Name Of Dam: LAKESIDE

PHASE I INSPECTION REPORT NATIONAL DAM SAFETY PROGRAM

NAME OF DAM: LAKESIDE
LOCATION: FREDERICK COUNTY, VIRGINIA
INVENTORY NUMBER: VA 06920

LAKESIDE DAM
FREDERICK CO. VA
29 OCT 80

PEZZA
PLATE 1

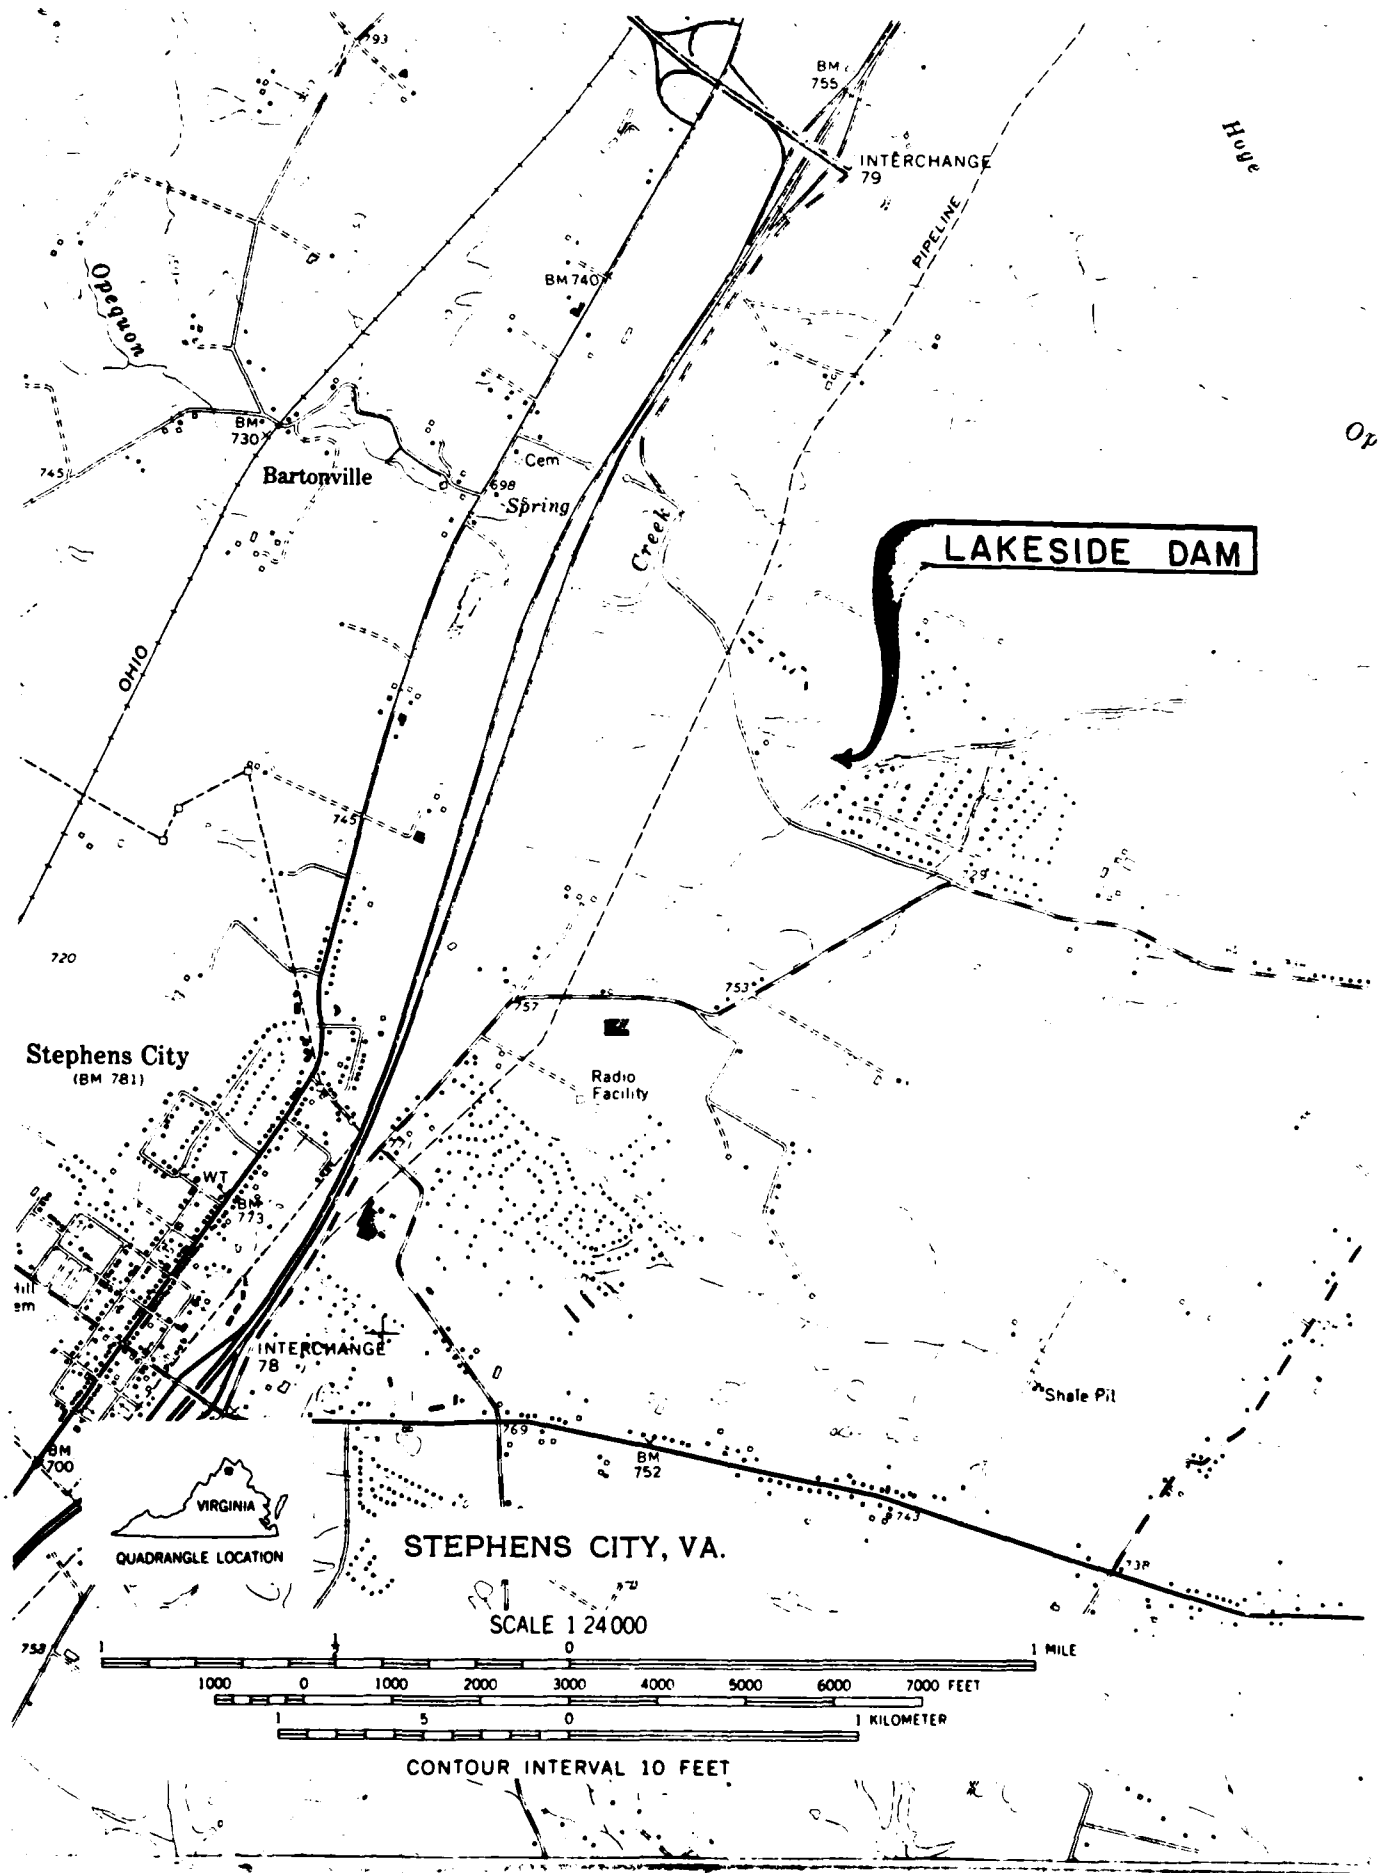
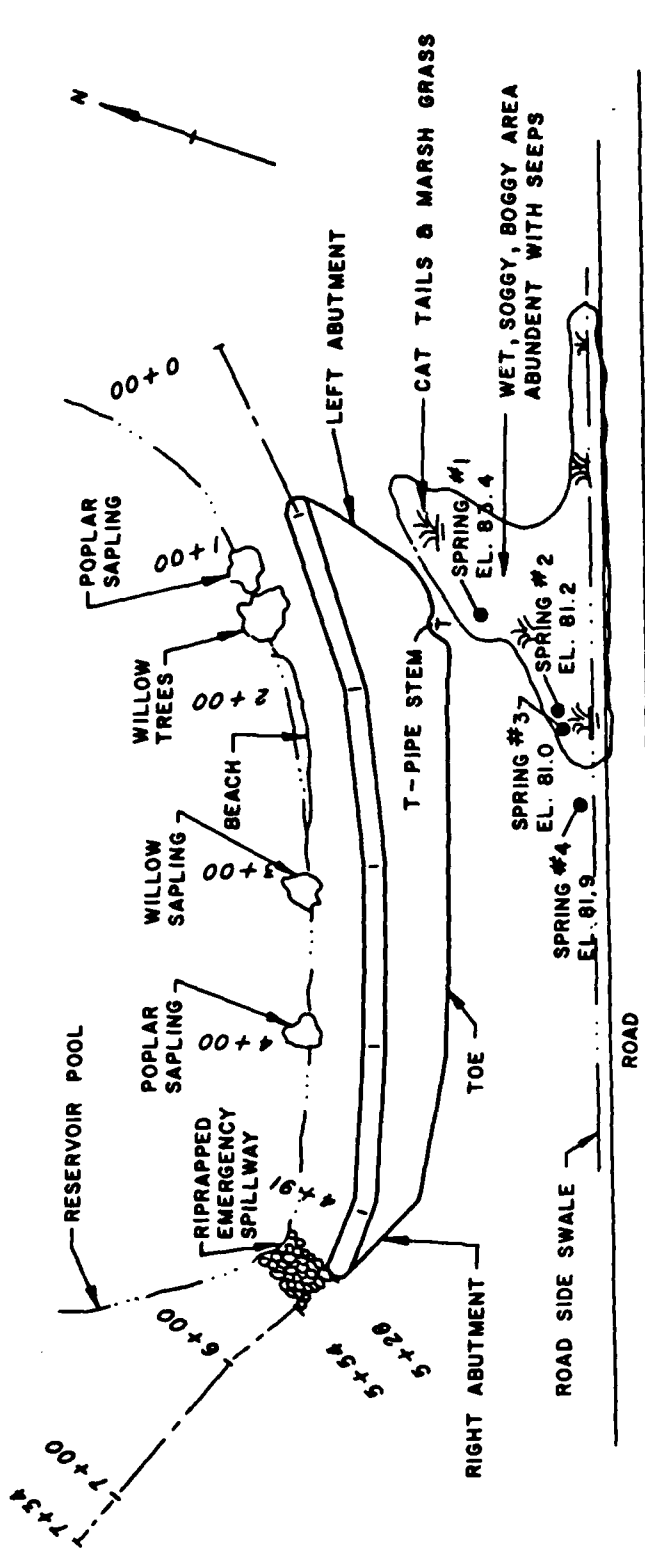
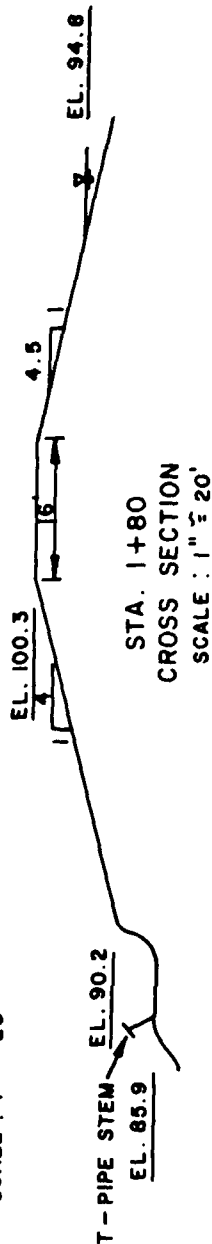
3.1.2 Embankment: The embankment is in good condition. A sketch showing a plan view and cross section is provided on Plate I, Appendix I. A crest profile is given on Plate II, Appendix I. Overall views of the crest and downstream face of the dam and of the reservoir area are provided at the beginning of the report.

A marshy area of considerable extent exists beyond the toe of the dam on the lefthand side, and there are several separate seeps or springs evident within or adjacent to this area, as indicated on the plan view. One of these, with a flow estimated to be 1 to 2 gpm, is located a short distance downhill from the "T" pipe valve stem, and may be seepage from the low level drain pipe. This valve stem is reported to have been damaged by a bulldozer working on the site.

PLATE 2

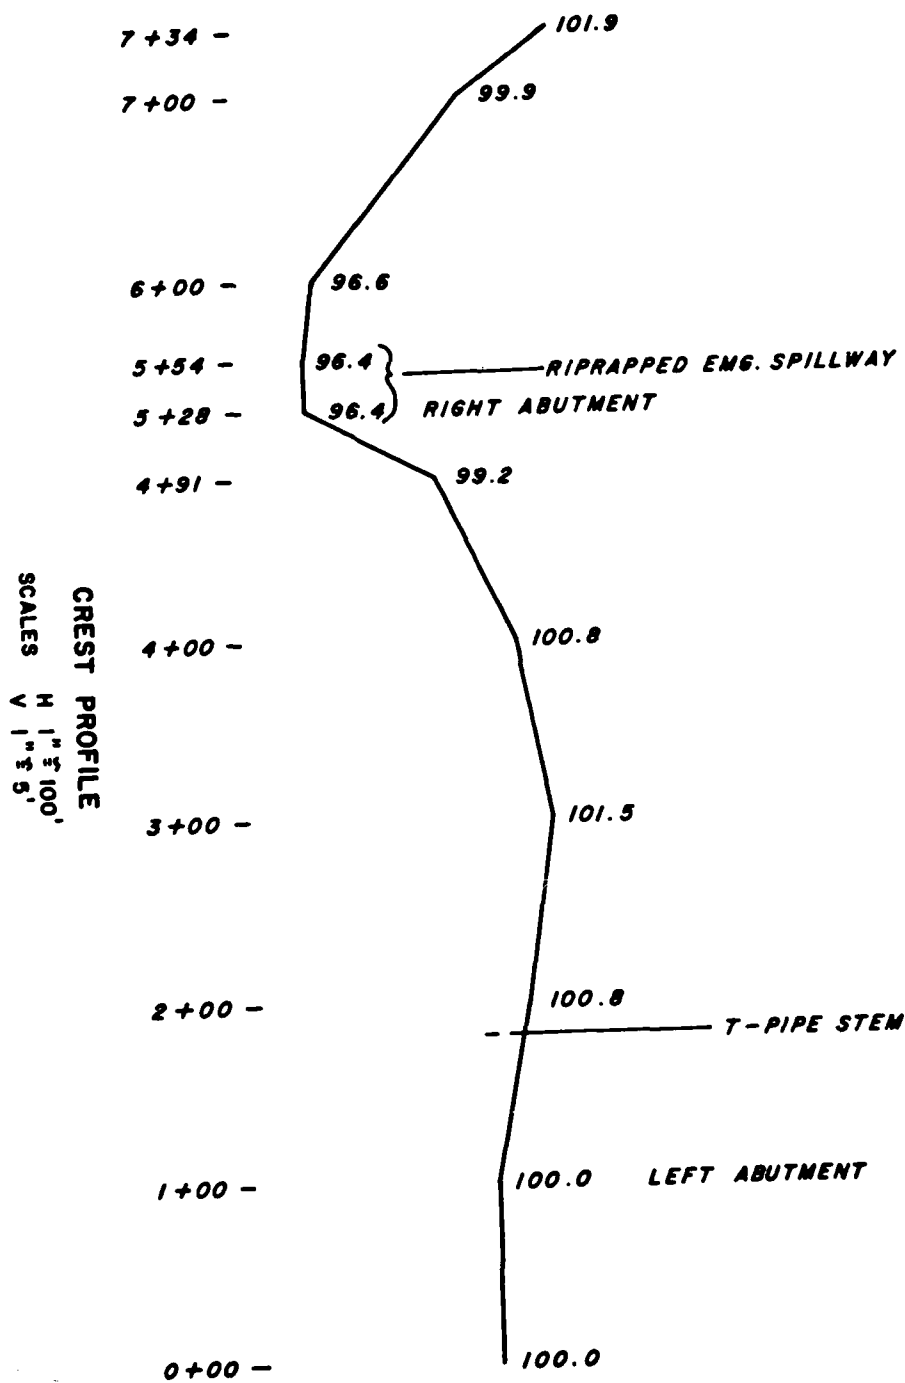
*The low point in the dam crest was used for Table 1.1, See Plate 2, Appendix 1 for elevations along crest of dam.
